Oceana Gold Deepdell North Stage III project – Initial review

At your request I have read the relevant sections of the report “*Oceana Gold (NZ) Ltd - Deepdell North Stage III Project: Assessment of Environmental Effects*” (‘the report’), including Chapters 1, 2, 3,5 and 7 and Appendices E, O and S. In this memorandum I provide a review of the methodology and conclusions of the Aquatic Ecology Effects Assessment (Appendix O of the report) and the Water Quality Effects Assessment (Appendix E of the report), outline the additional information required to finalise my assessment and present recommendations on the proposed consent conditions (Appendix S of the report).

Figure 1: Watercourse map. The western tributary of Highlay Creek that could be impacted by discharges is indicated by red oval, the Gully Stream which will be reclaimed is indicated by the purple oval and the Highlay Tributary that will be culverted is indicate by the orange oval. .

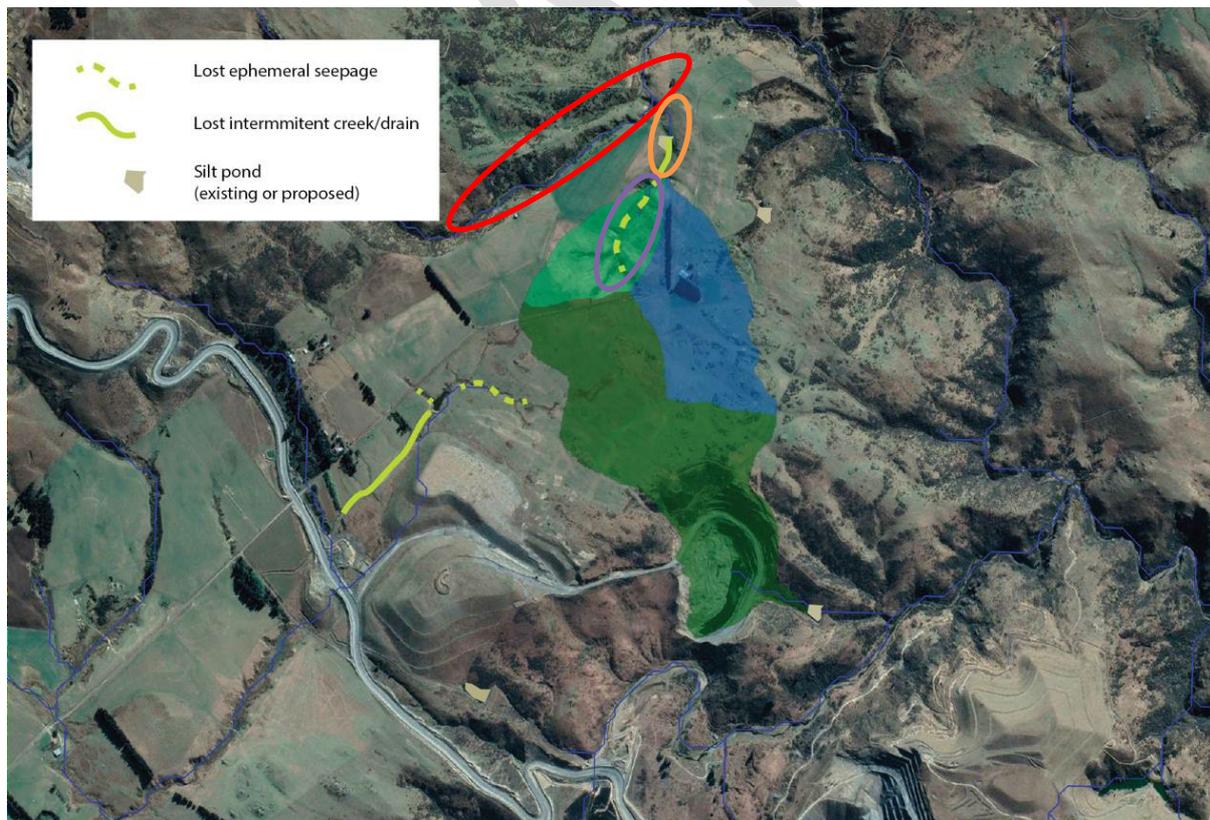
In my opinion the effects of the discharge of contaminants to Highlay Creek or its Western Tributary (location shown in Figure 1) have not been properly assessed in the Ecological Effects Assessment. In that report, they have only discussed the potential to effects to arise from sulphate and nitrate. However, the effects of toxicants such as arsenic have not been considered. To complete my full assessment, I require the applicant to assess the ecological effects of the discharge standards requested for Highlay Creek in Section 2.2.2. (including nutrients and their effects on periphyton).

The applicant is proposing to reclaim approximately 480 metres of stream in the Highlay Creek catchment (hereafter referred to as the “Gully Stream” (location shown in Figure 1)) that runs down a gully within the proposed project footprint. In the Ecological Effects Assessment it is estimated that approximately 250 metres of this is ephemeral and the remaining 130 metres is potentially intermittent. The Ecological Effects Assessment also suggests that these reaches do not support fish or typical stream invertebrate habitat and associated communities, and are unlikely to carry surface flow during warmer months of the year. Based on this assessment it is concluded that the effects of reclamation will be minor in the report.

In addition to reclaiming 480 metres of the Gully Stream, the applicant is proposing to construct a 51m culvert in an intermittent reach further downstream (hereafter referred to as the “Highlay Tributary” (location shown in Figure 1)) as part of a road realignment. The effects of this culvert have not been explicitly assessed in the Ecological Effects Assessment. While not a major issue, some form of assessment is needed, particularly around construction effects (habitat effects are likely the same as those caused by the reclamation of the Gully Stream).

- The likely contaminant concentrations in both Highlay Creek and its Western Tributary (location shown in Figure 1) and proposed water quality standards for these creeks that can be applied in consent conditions. For nutrients, these standards should be set to control plant growth rather than toxicity.

- Some form of assessment of the effects of culverting the “Highlay Tributary” (location shown in Figure 1), particularly around construction effects (habitat effects are likely the same as those caused by the reclamation of the Gully Stream).
